ENVIRONMENTAL IMPACT STATEMENT

Expansion of Redbank Copper Operations

SUPPLEMENT

Figure 6.3-1: Environmental Monitoring Bore Map

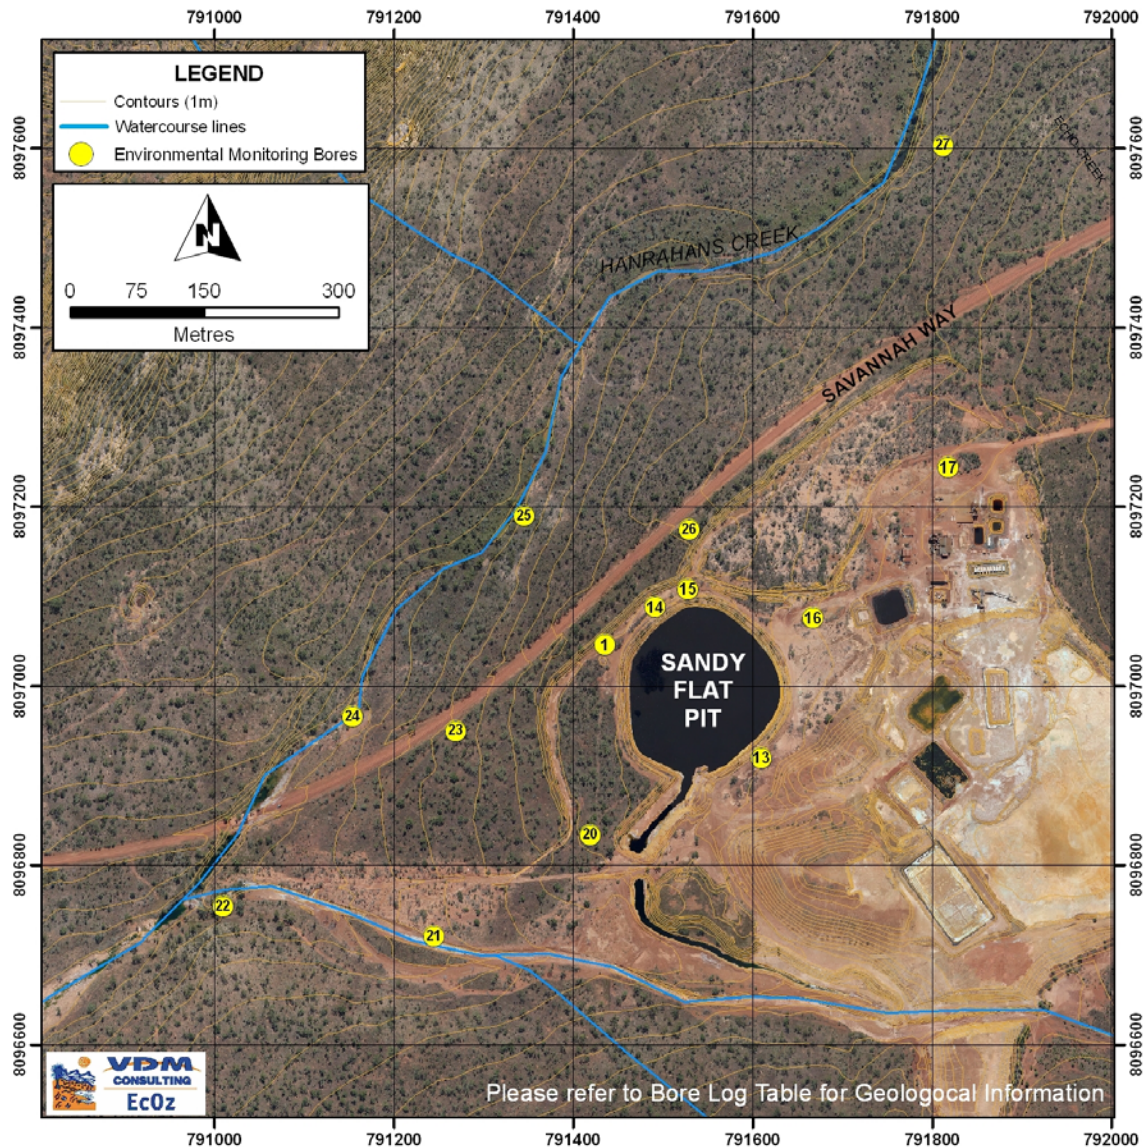
Water Resources 09	The location of any new monitoring bores should be supported by the hydrogeological model. Geological and hydrogeological information (cross-sections, geological log of bores, maps) obtained from previous documentation and description of the mineral deposit should be included in the EIS to better explain its relationship to the hydrogeology of the area.
----------------------------------	--

EHA (NRETAS) 27	The information in Table 6.3.5 should be placed on a geological map with corresponding bore water quality data to assist in understanding of groundwater condition in the region as per the EIS guidelines (section 6 and 6.3.3, EIS Guidelines September 2009): 1. Geological plans and cross sections of the area to provide an understanding of the spatial nature of the deposits and existing relevant hydrogeological information; 2. Describe with suitably detailed maps the geology and aquifers underlying the waste water, rock storage and surrounding areas, to the outer extent of the underlying aquifers. Contour maps should include overlays of all proposed infrastructure; 3. Describe surface connections and expressions of groundwater aquifers potentially affected by the waste water, waste rock and tailings facilities.
-----------------------------------	--

Figure 6.7-3: Proposed Waste Rock Dump for Redbank and Azurite open cut pits.

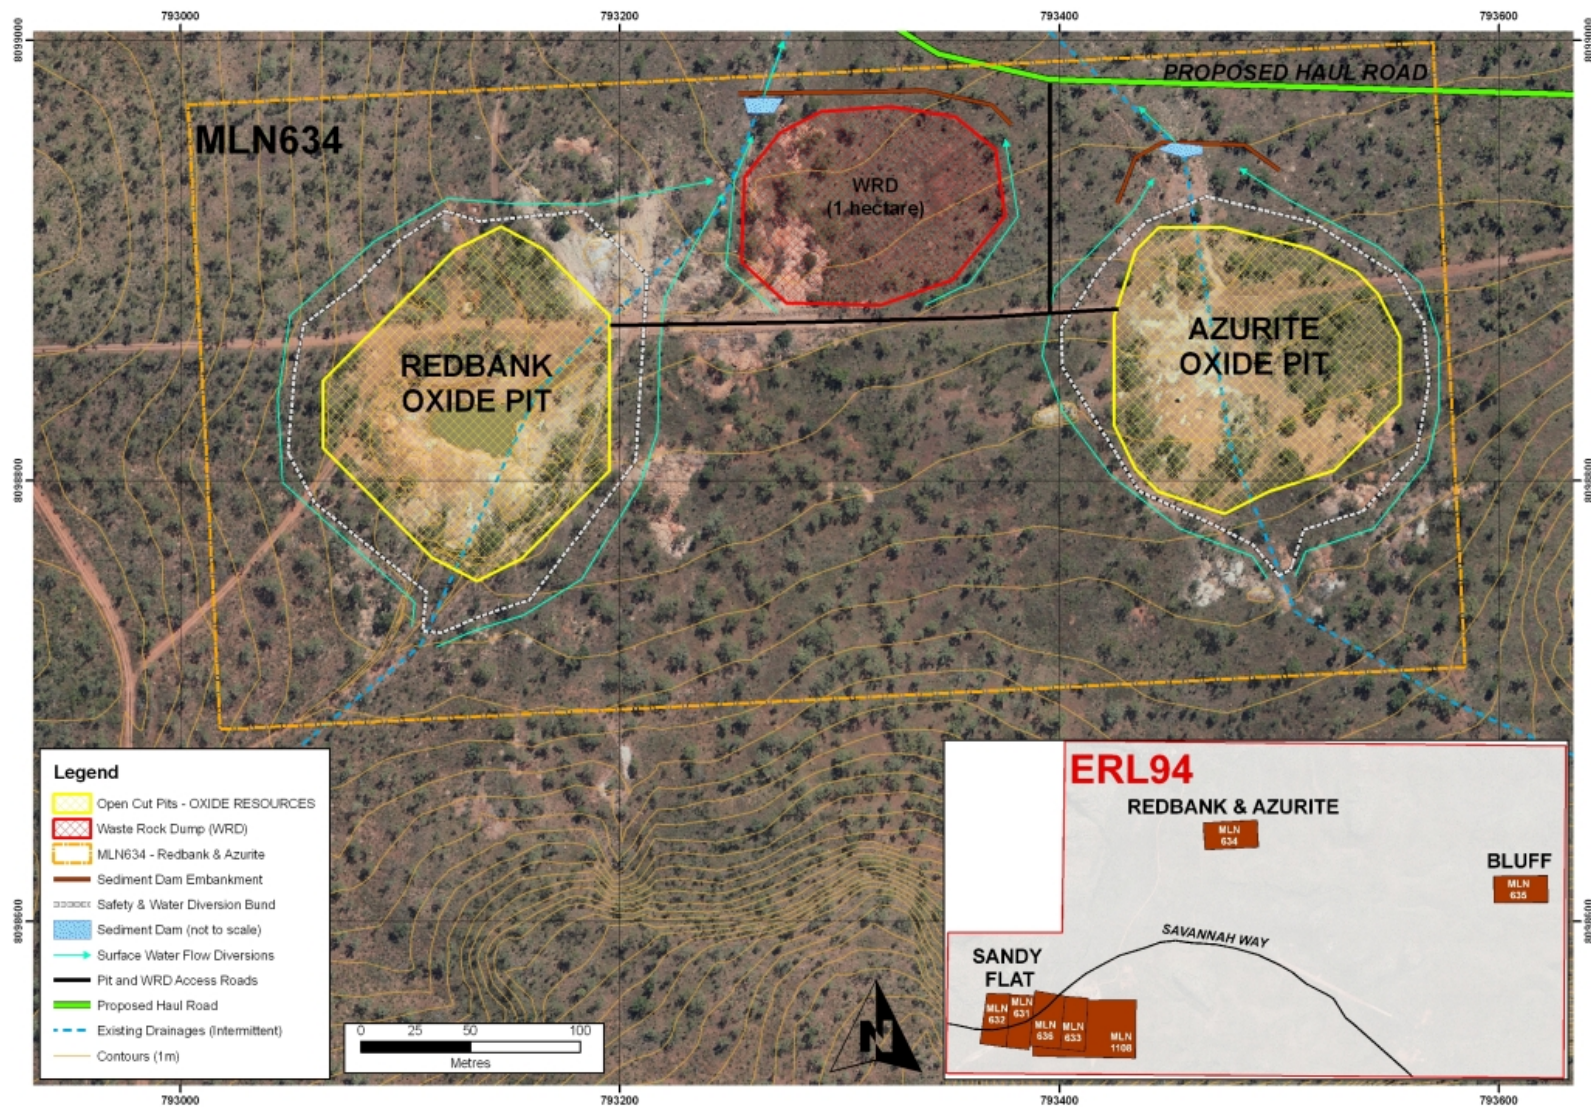
EHA (NRETAS) 37	In the Draft EIS it is stated that proposed new open pits, waste rock dumps and other expansions will be located deliberately away from natural watercourses (section 6.3.3). Justification needs to be given in the supplement as to why the waste rock dump for the bluff deposit appears to be located on a drainage course (Figure 3.4.1).
------------------------	--
